Project	IEEE 802.16 Broadband Wireless Access Working Group < http://ieee802.org/16 >		
Title	Modified structure of the 802.16h Working Document		
Date Submitted	2006-07-10		
Source(s)	Wu Xuyong, Huawei, Mariana Goldhamer, Alvarion Grandblaise David, Motorola John Sador, CRC Avi Freedman, Hexagon	Voice: Fax:	+86 755 28780808 wuxuyong@huawei.com marianna.goldhammer@alvarion.com david.grandblaise@motorola.com john.sydor@crc.ca avif@hexagonltd.com
Re:	IEEE 802.16h-06/016 –Second Working Group Review: Working Document for P802.16h (2006-06-05)		
Abstract	The updated revision of IEEE C802.16h-06/046 during the discussion in [16h-TOC] ad-hoc group revision 1.		
Purpose	Proposes a more logical structure which will allow better understanding of the existing mechanisms		
Notice	This document has been prepared to assist IEEE 802.16. It is offered as a basis for discussion and is not binding on the contributing individual(s) or organization(s). The material in this document is subject to change in form and content after further study. The contributor(s) reserve(s) the right to add, amend or withdraw material contained herein.

Modified structure of the 802.16h Working Document- With comments

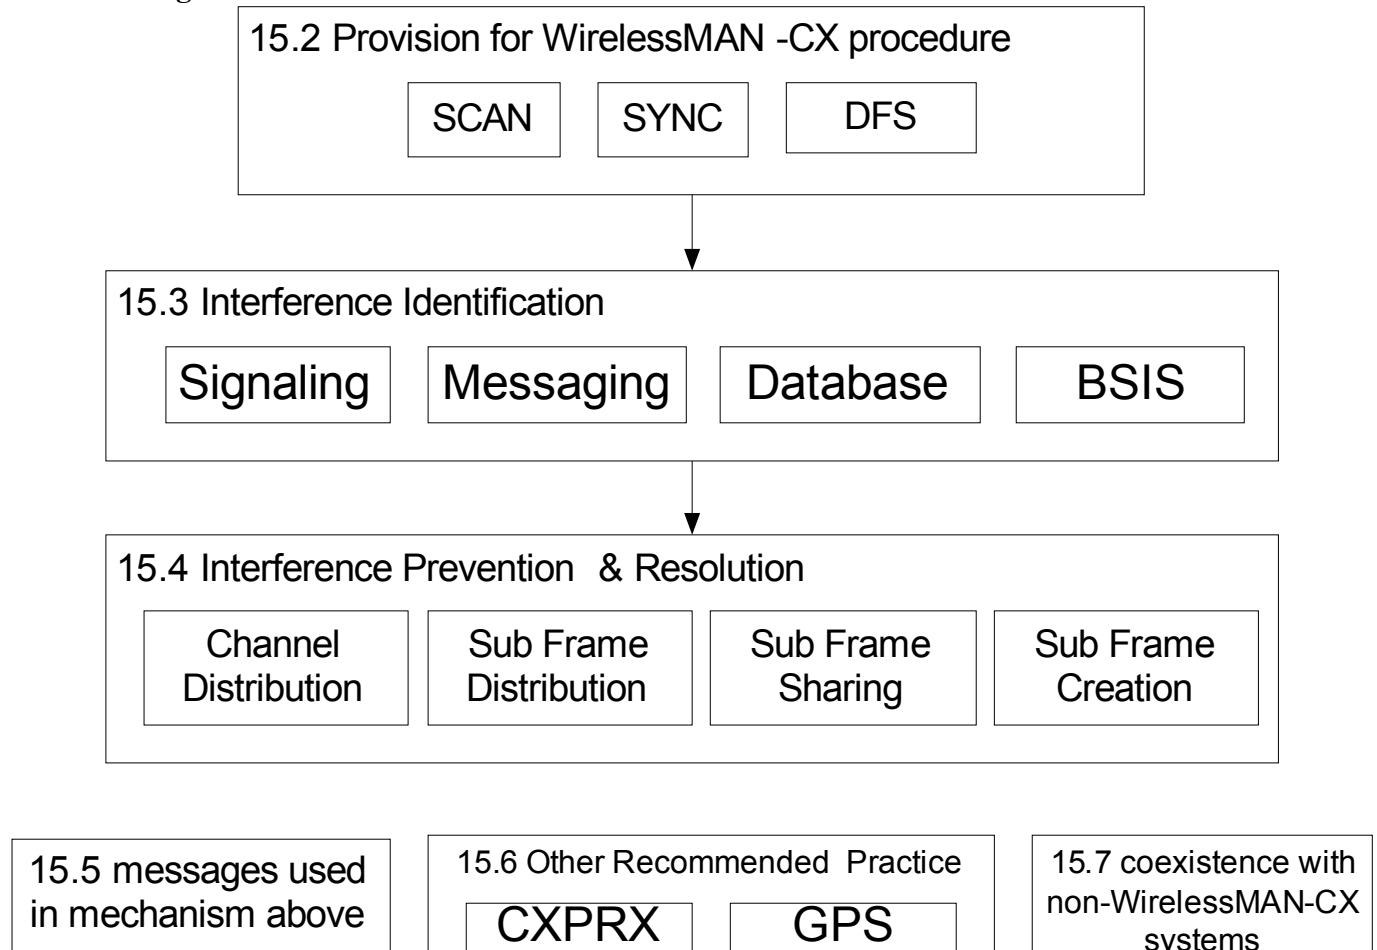
-15.1.4.1.1	Coexistence signaling interval	15.2.1.1.3	No change in text
-15.1.4.1.2	Coexistence messaging interval	15.2.1.1.7	No change in text
-15.1.4.2	Frame Structure for interference prevention & Resolution	15.2.1.1 29/63-31/40 (Comment by Mariana: this text is not related to the frame structure; Mariana, would you give some proposal on this text?) insert a sentence pointing to frame structures detailed in 15.4.2	See C80216h-06_048 old colorful figure have been redrawn by editor – (Mariana: The figure needs some revision) A figure added indicating the examples of subframes

Insert this figure in 15.1.4 after the mechanism list
